SHAYER 2ND ADDITION

RE: SUB 2002-48 -- One-Step Final Plat of Shaver Addition.

At the regular meeting of the Subdivision Committee of the Metropolitan Area Planning Commission on Thursday, June 27, 2002, the above captioned plat was considered. The action of the Committee was to approve the one-step final plat, subject to the following:

CASE NUMBER: SUB 2002-48 -- SHAVER ADDITION

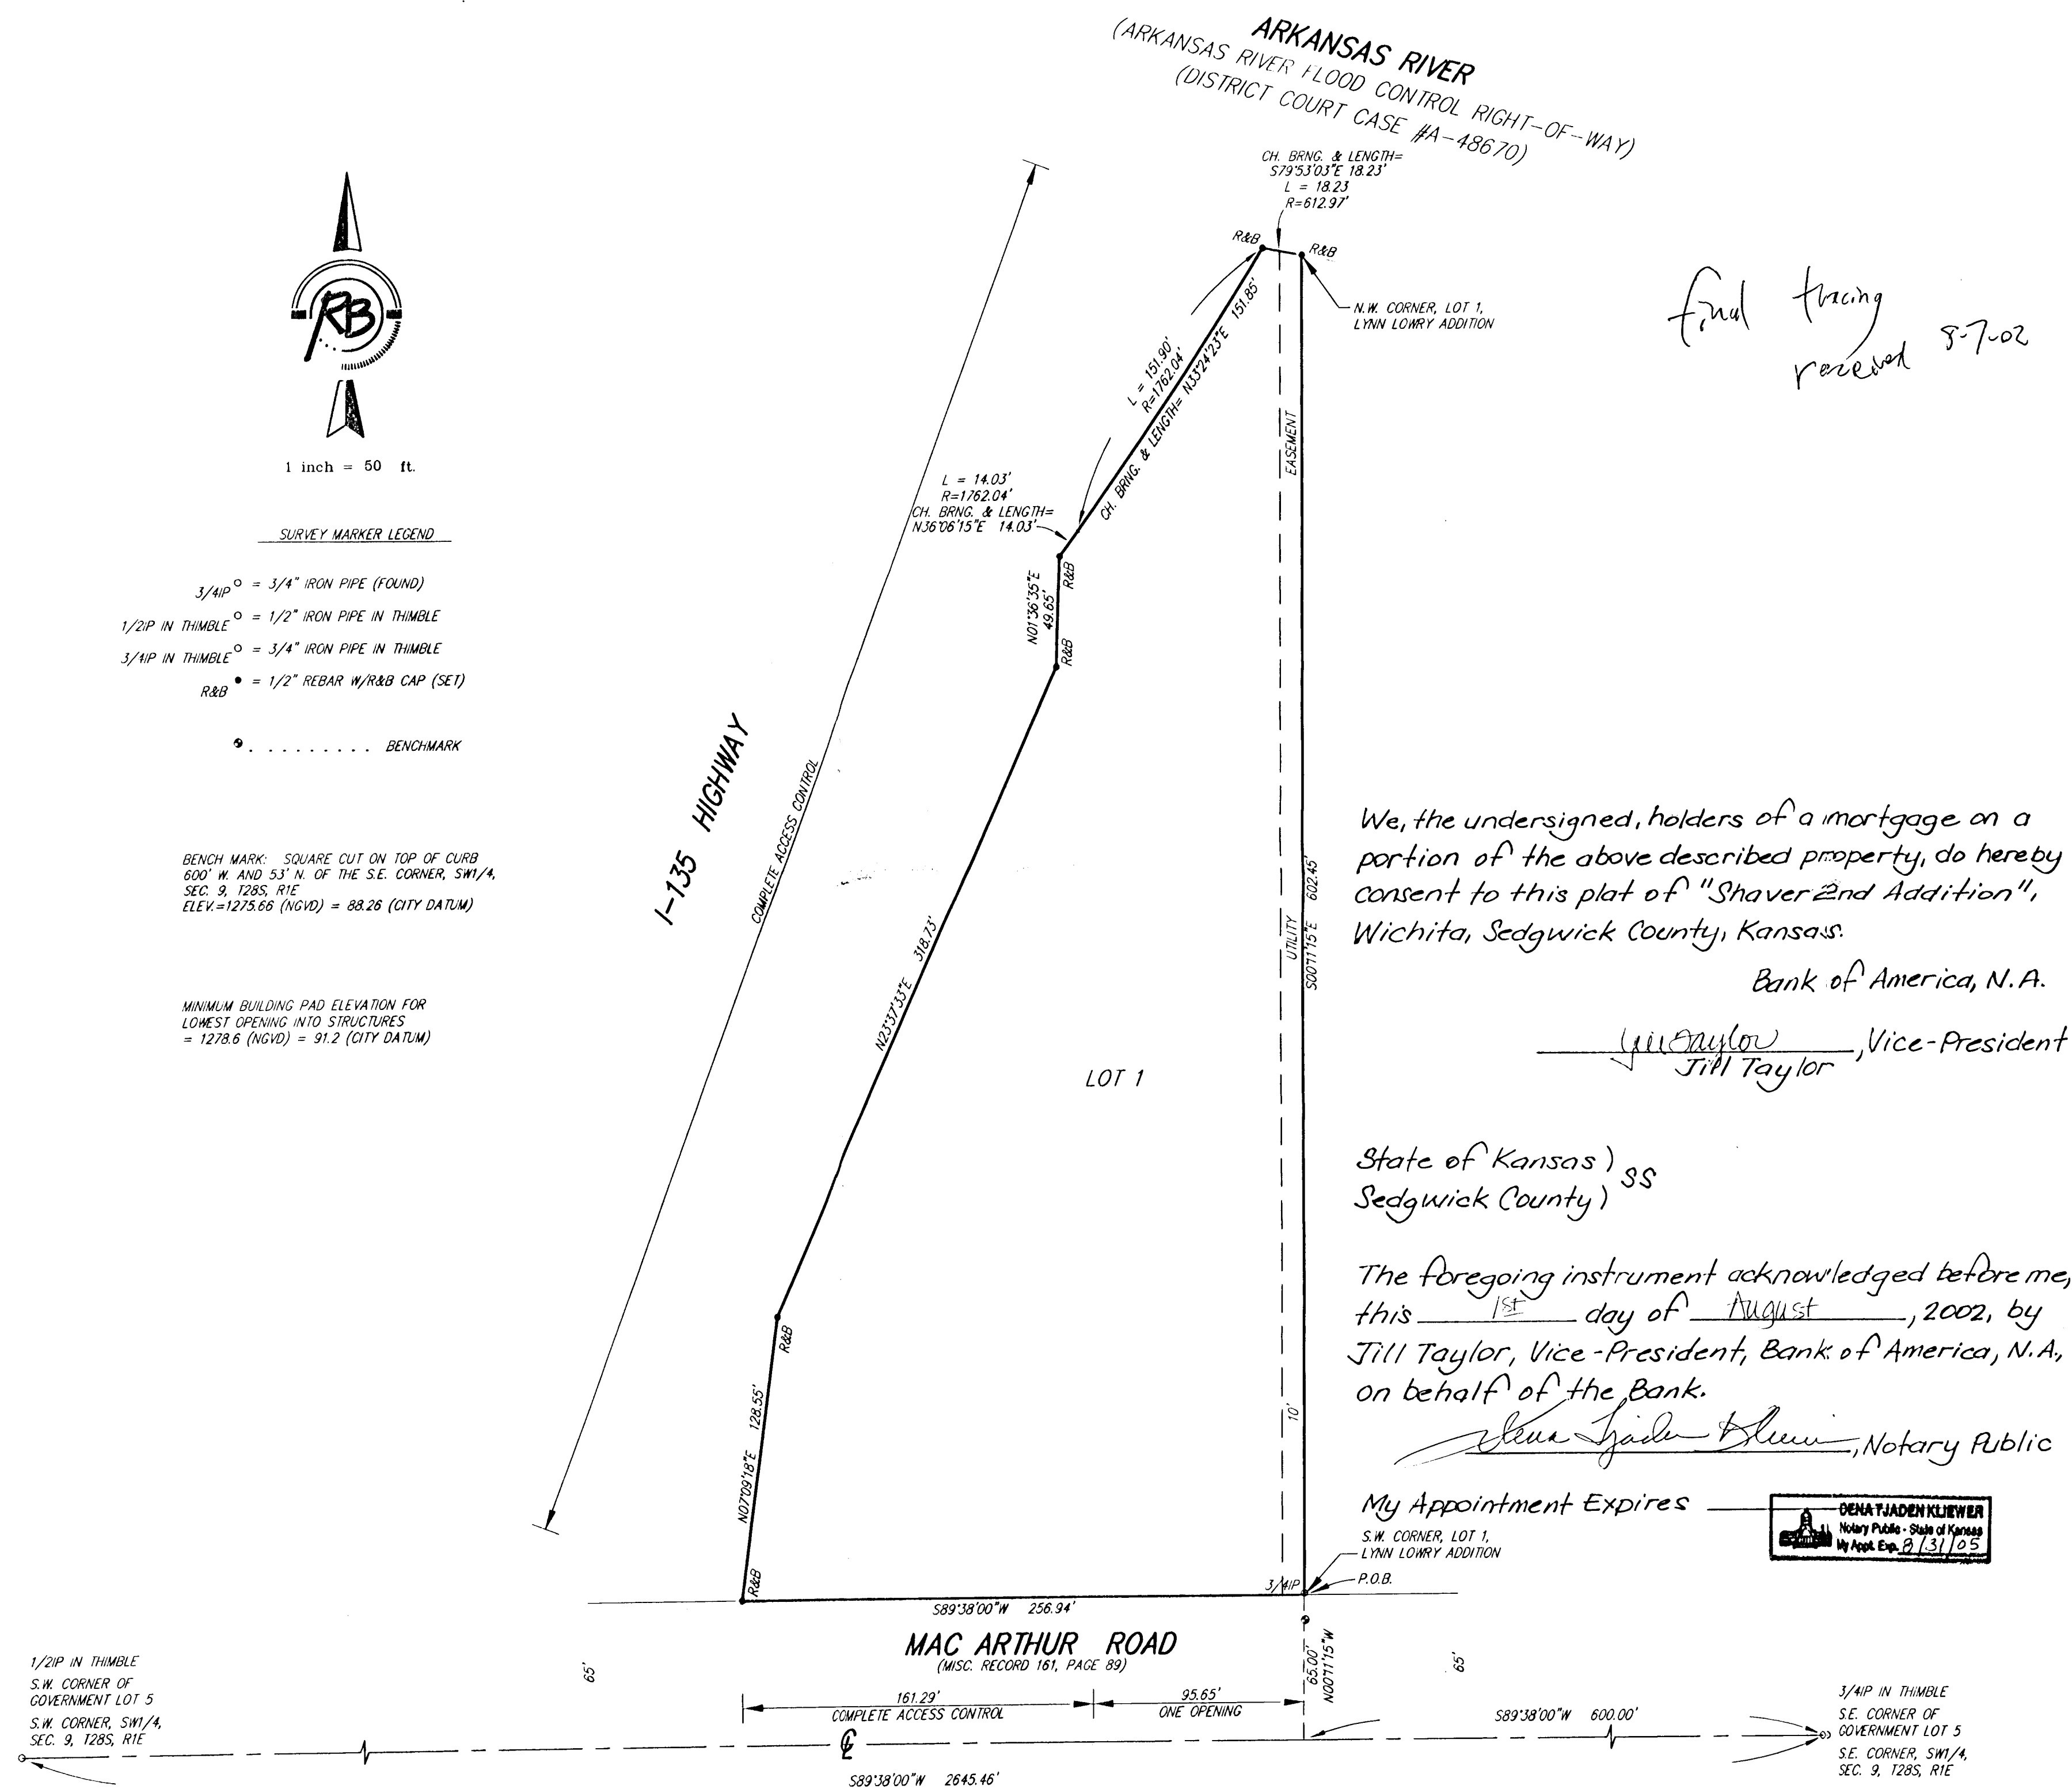
- A. Public water is available to serve the site. City Engineering needs to comment on the need for guarantees or easements. A 10-ft utility easement is needed along the east line of the plat.

- E. City Engineering needs to comment on the status of the applicant's drainage plan and on any need for the platting of floodway or drainage easements, or minimum building pads. Minimum building pads need to be platted.

- F. Traffic Engineering needs to comment on the access controls, particularly the need for a specific location for the access opening. The plat proposes one access opening along MacArthur Road. Traffic Engineering has approved the access controls.

- I. On the final plat, the MAPC signature block needs to reference "J.D. Michaelis, Chair".
- J. The final plat shall be submitted with a revised name as an Addition now within Wichita exists with the name "Shaver Addition".

- K. County Surveying has noted that in the legend the property corner symbols need to be differentiated.
- L. County Surveying has noted that the benchmark needs city datum.

- M. County Surveying has noted that the Wichita Valley Center Flood Control language needs to be removed from the face of plat and platlor's text. Arkansas River Flood Control right-of-way language needs to be added with recording data.

- N. County Surveying has noted that the legal description needs to reflect the owner's deeds and then can be more particularly described as the legal shown.

- O. County Surveying has noted that MacArthur Road needs recording data.
- P. The Applicant is reminded that a platting binder is required with the final plat tracing. Approval of this plat will be subject to submittal of this binder and any relevant conditions found by such a review.

- Q. The platlor's text shall include language that a drainage plan has been developed for the plat and that all drainage easements, rights-of-way, or reserves shall remain at established grades or as modified with the approval of the applicable City or County Engineer, and unobstructed to allow for the conveyance of stormwater.
